Re: FortisBC Inc. (FBC)

Project No. 1599088

Application for a Certificate of Public Convenience and Necessity for the Kelowna Bulk Transformer Addition Project (the Application)

Response to the British Columbia Utilities Commission (BCUC) Information Request (IR) No. 1

Figure 3-2: Kelowna Area Transmission System

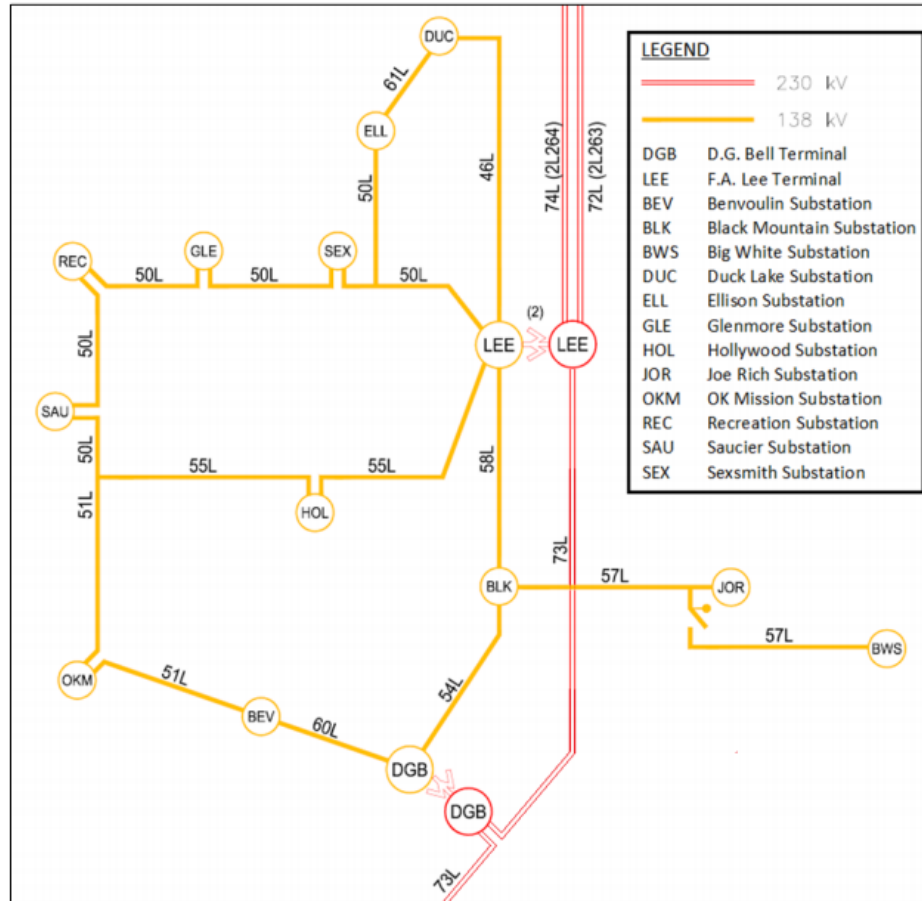
8 6.8 Please discuss if FBC considers transmission line 57L, as shown in Figure 3-2,
9 to be a radial transmission line.

Normal System Configuration

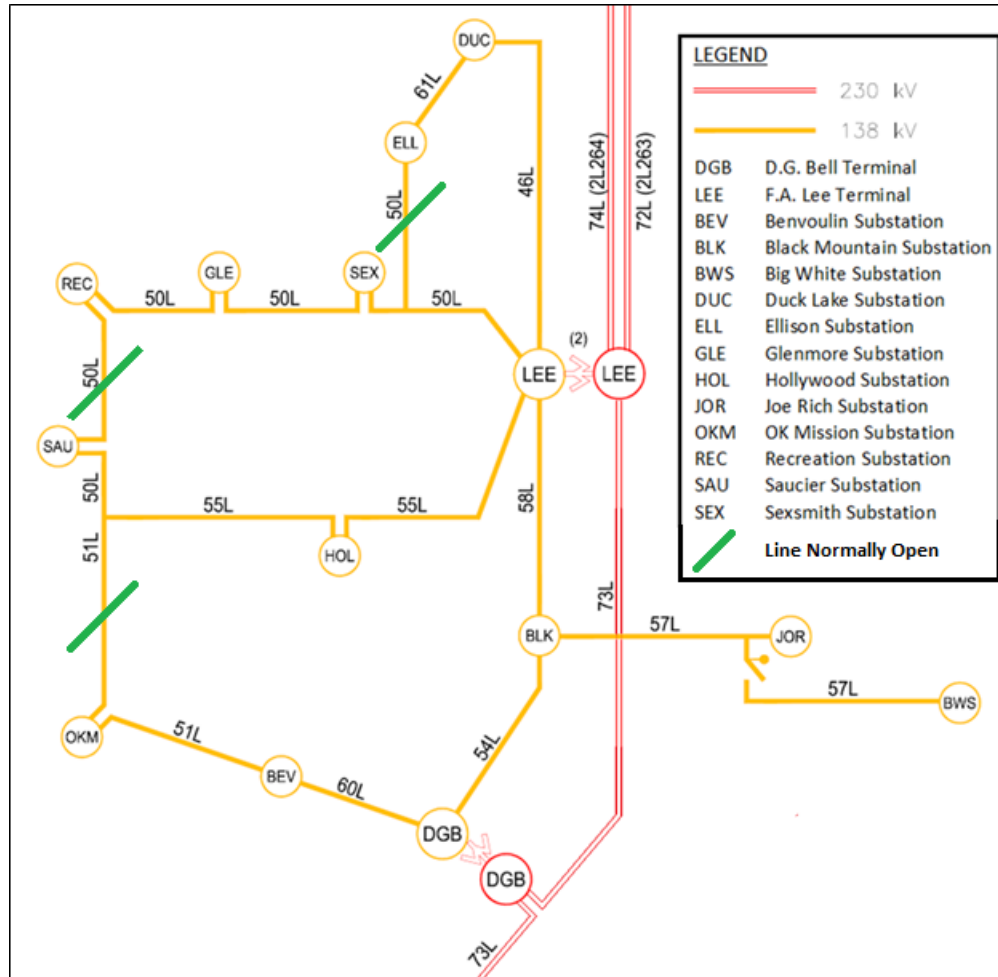
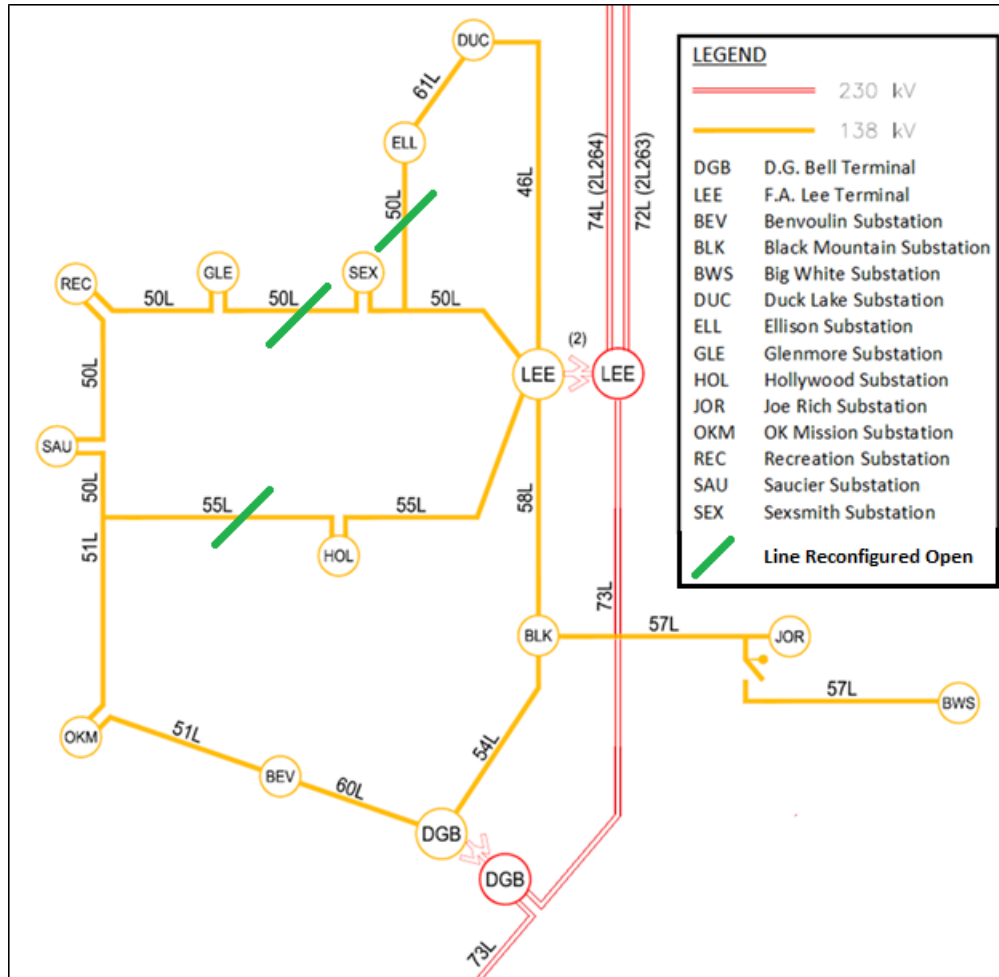
7.5.1 Please provide an update to Figure 3-2 to show the 138 kV system before and after the noted system reconfiguration.

The 138 kV system is reconfigured when either LEE T3 or T4 goes out of service to reduce the post contingency flow on the remaining transformer. This is done by closing the OKM-SPR Tap and SAU-REC line sections and opening HOL-SPR Tap and SEX-GLE line sections. This results in more optimal distribution of the post contingency power flow between the remaining LEE and DGB transformers. Please refer to the figures below.

Figure 4-1: Kelowna Area Peak Loads and N-1 Transformer Limits (LEE Alternatives)

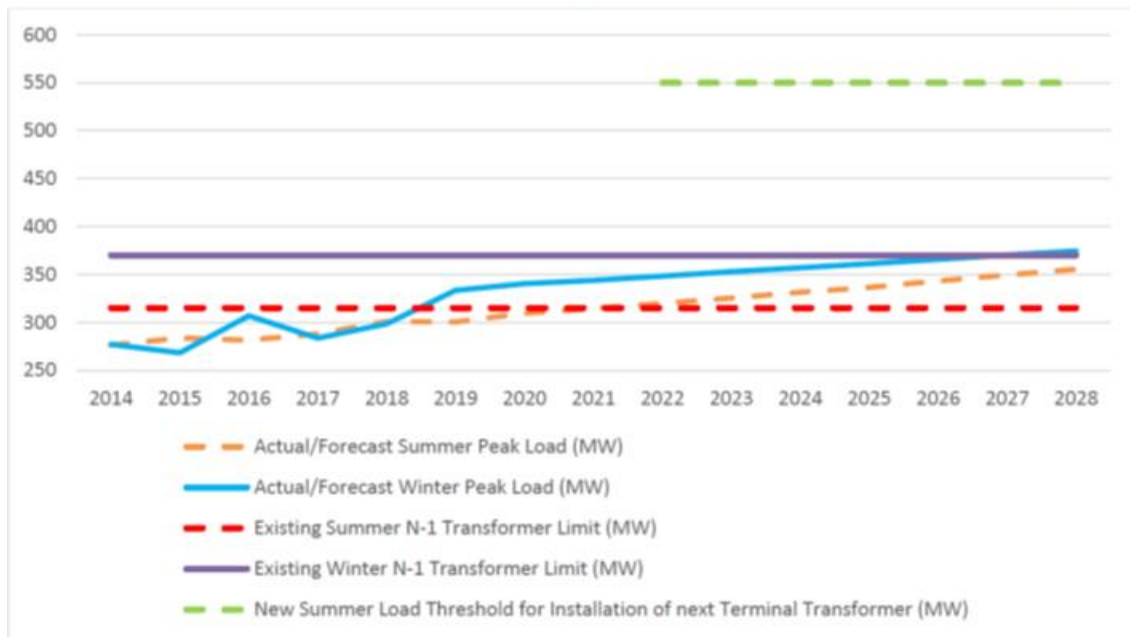
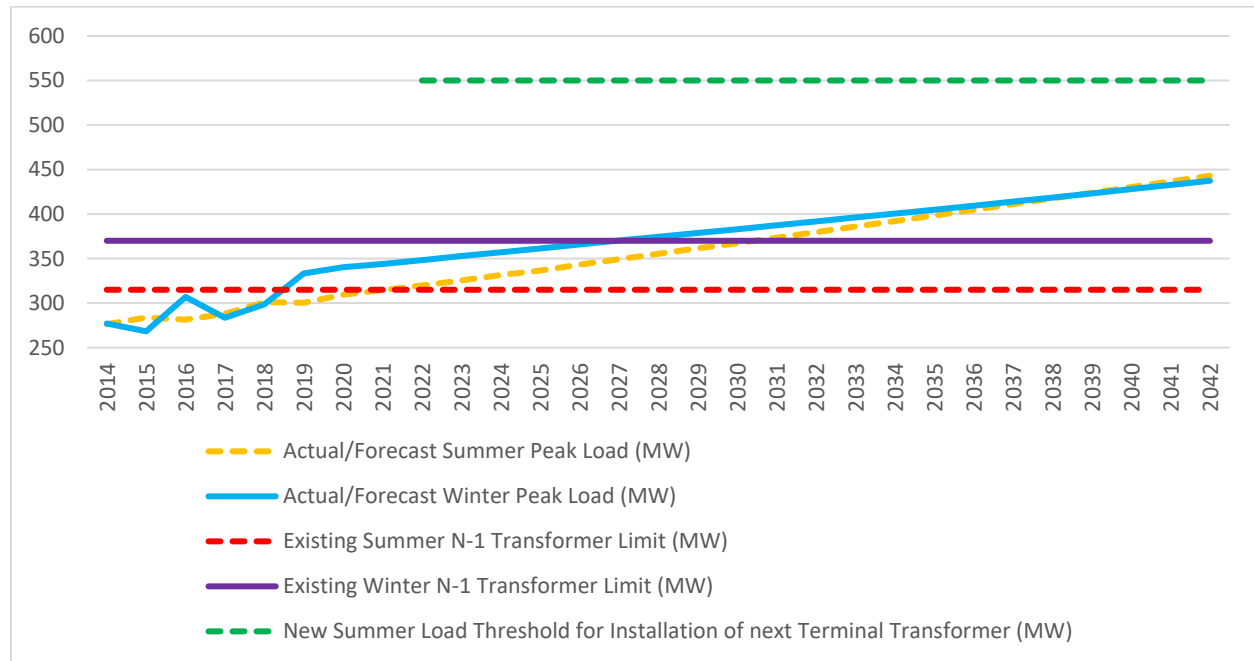
11.1 Please update Figure 4-1, with the time axis extending to 2042, 20 years beyond the in-service date of the project.

Figure 4-1A: Kelowna Area Peak Loads and N-1 Transformer Limits (LEE Alternatives) Extended to 2042

**Figure 4-2: Kelowna Area Peak Loads and N-1 Transformer Limits
(DGB Alternative with 60L and 51L Reconductoring)**

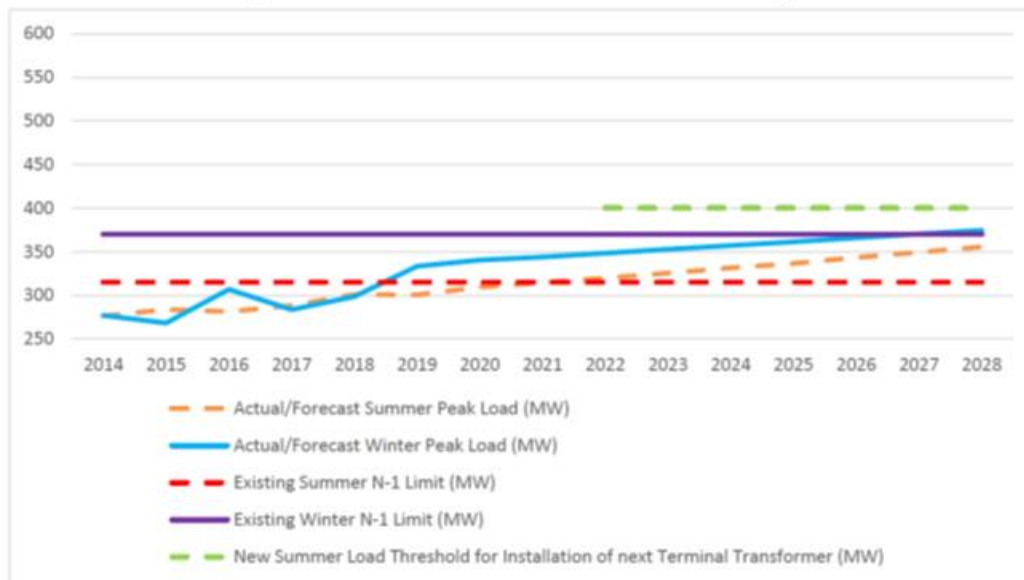
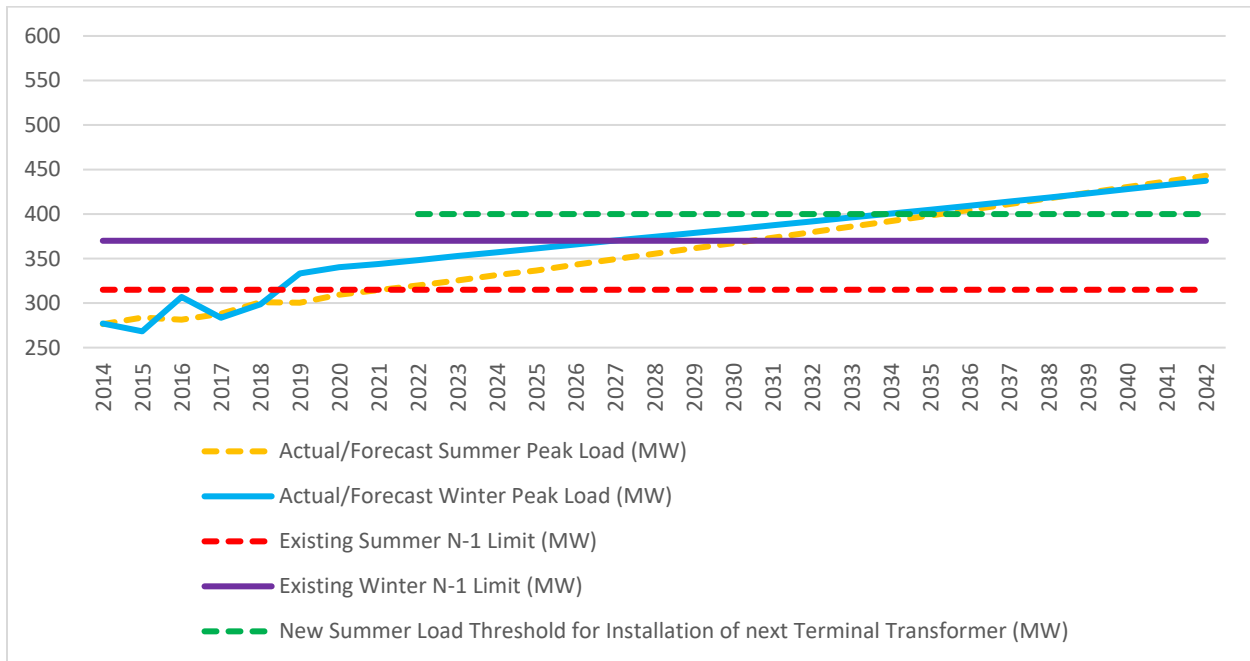
14
15 11.4 Please update Figure 4-2, with the time axis extending to 2042, 20 years beyond
16 the in-service date of the project.
17

Figure 4-2A: Kelowna Area Peak Loads and N-1 Transformer Limits (DGB Alternative with 60L and 51L Reconductoring) Extended to 2042

Figure 5-1: LEE Terminal Ring Bus Simplified Single Line Drawing

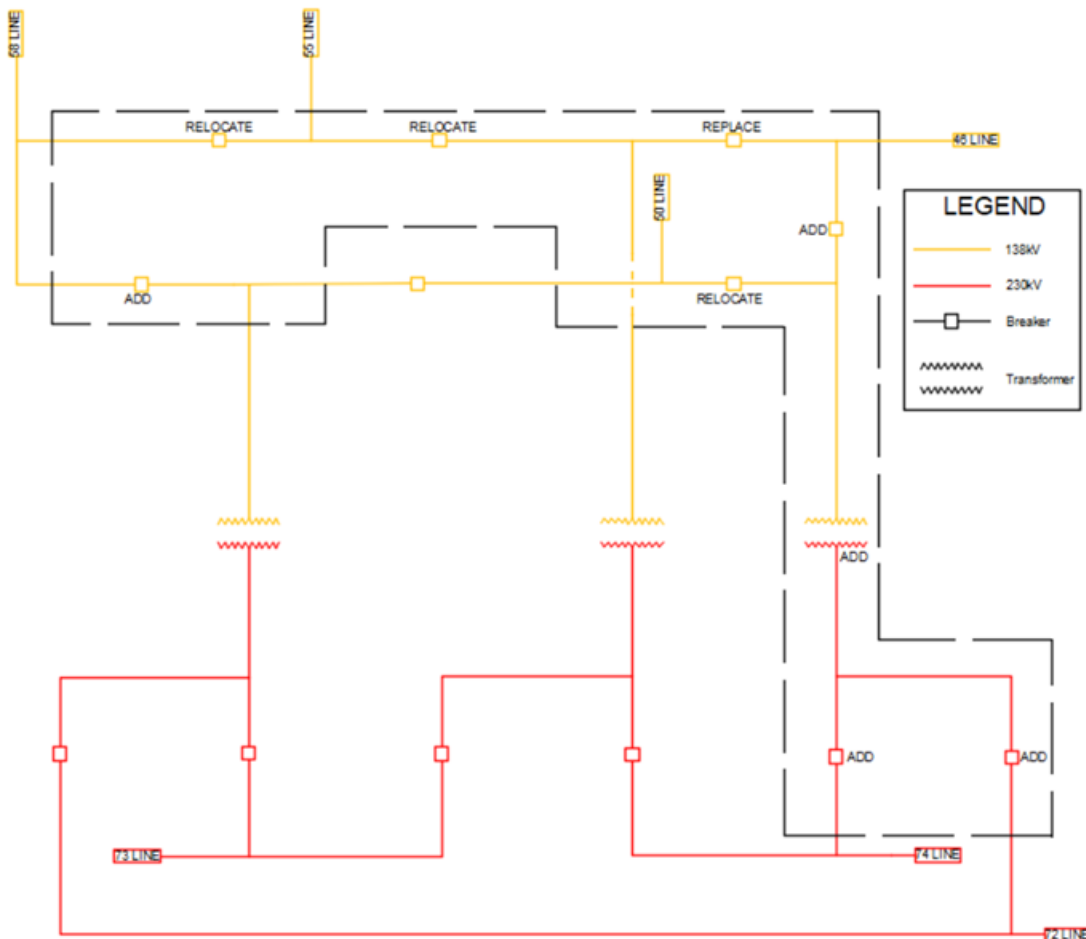
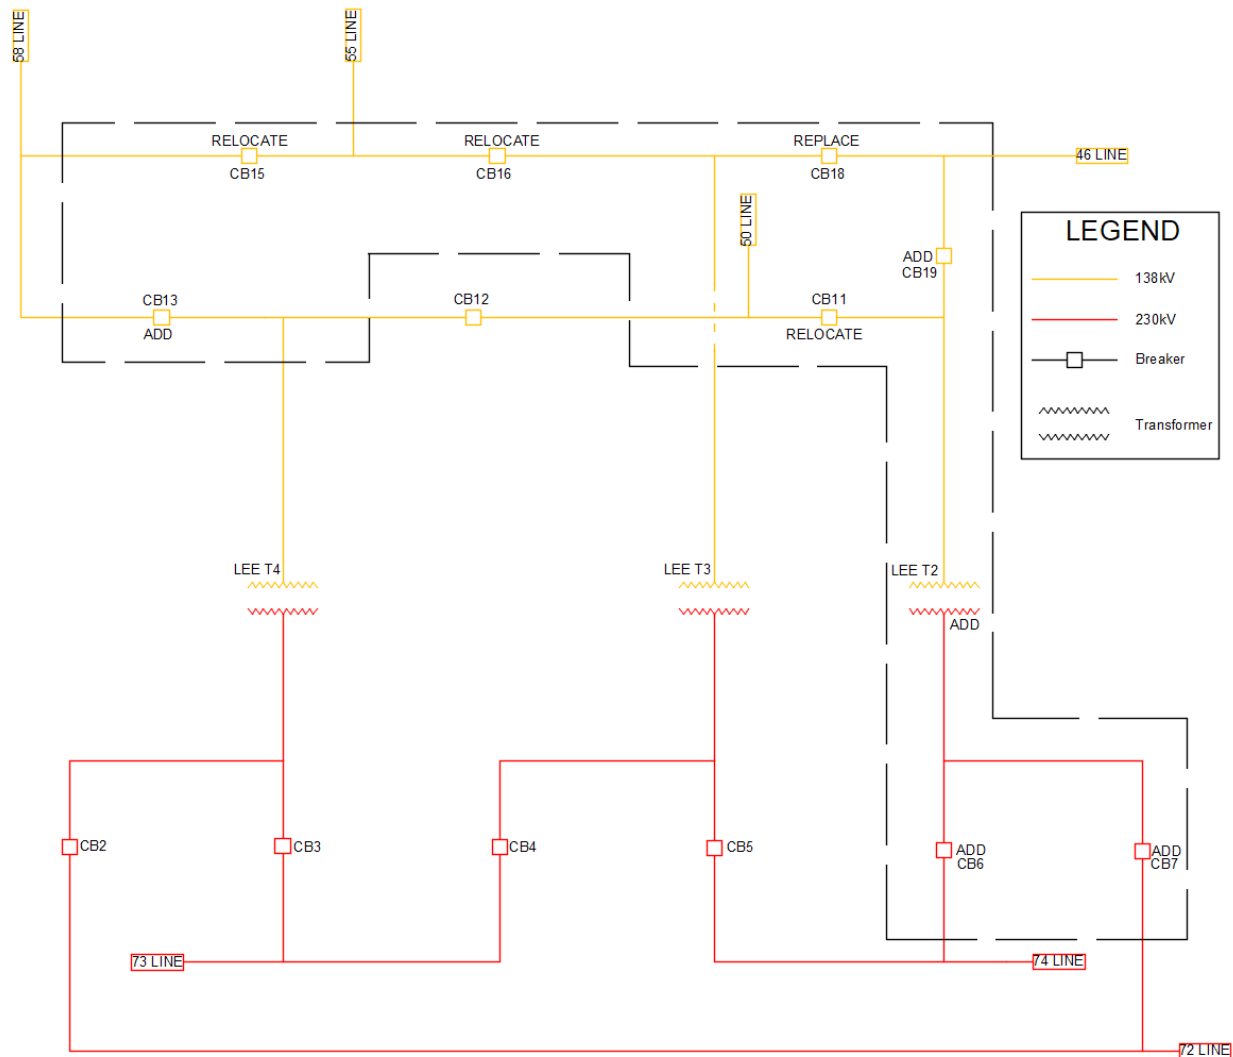
18.1 Please provide an updated Figure 5-1, with the transformers and circuit breakers labelled.

Please refer to the updated figure below which includes the labelled transformers and circuit breakers.

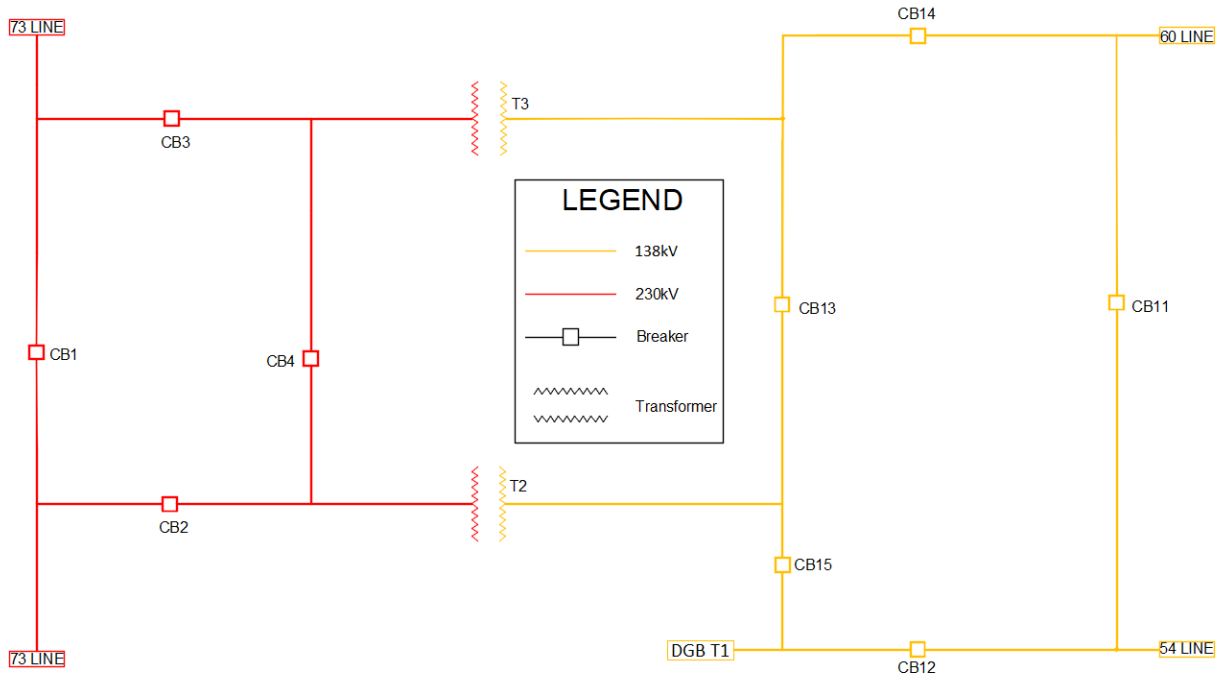
18.5 Please provide a similar Simplified Single Line Drawing for DGB substation under Alternative C.

Please refer to the simplified single line drawing below for DGB substation under Alternative C.
